**World Forum for Harmonization of Vehicle Regulations****Working Party on General Safety Provisions****125th session**

**Awareness of the Proximity of Vulnerable Road Users:  
UN Regulation No. 46 (Devices for indirect vision)****Proposal for Supplement 1 to the 05 Series of Amendments to  
UN Regulation No. 46 (Devices for indirect vision)****Submitted by the expert from the International Organization of Motor  
Vehicle Manufacturers \***

Figure (a): Traditional Outside Mirror

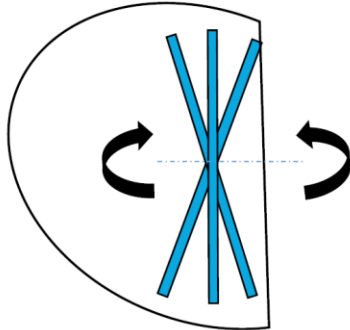
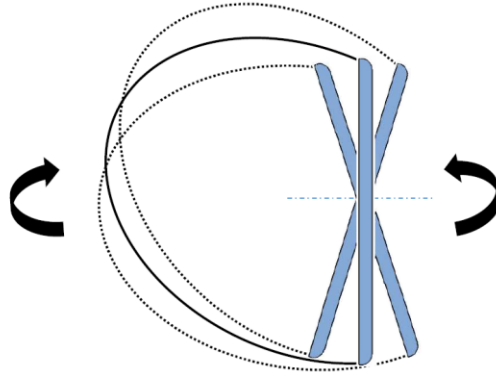
2. For Class II to VII mirrors, it is only possible to have a reflecting surface projecting beyond the housing in single adjustment positions. In this case, the reflecting surface must return into the protective housing if a force of 50 N is applied. This requirement cannot be met by mirrors where the reflecting surface is assembled onto the housing (frameless).

3. A frameless design of the mirror could reduce the width and height of the mirror significantly (up to 30 per cent). This would then have two major benefits: a reduction of collision probability with bicyclists/pedestrians and a reduction of the aerodynamic resistance ( $c_w$ ).

**In cases where the edge of the reflecting surface is enclosed in a protective housing (holder, etc.), the radius of curvature "c" on its perimeter shall be not less than 2.5 mm at all points and in all directions.**

**In cases where the edge of the reflecting surface projects beyond the protective housing independent from any adjustment position, the radius of curvature "c" shall apply to the edge of the projecting part.**

**In cases where** ~~If~~ the reflecting surface projects beyond the protective housing **in any adjustment position**, the radius of curvature "c" on the edge of the projecting part shall be not less than 2.5 mm and the reflecting surface shall return into the protective housing under a force of 50 N applied to the point of greatest projection, relative to the protective housing, in a horizontal direction, approximately parallel to the longitudinal median plane of the vehicle.
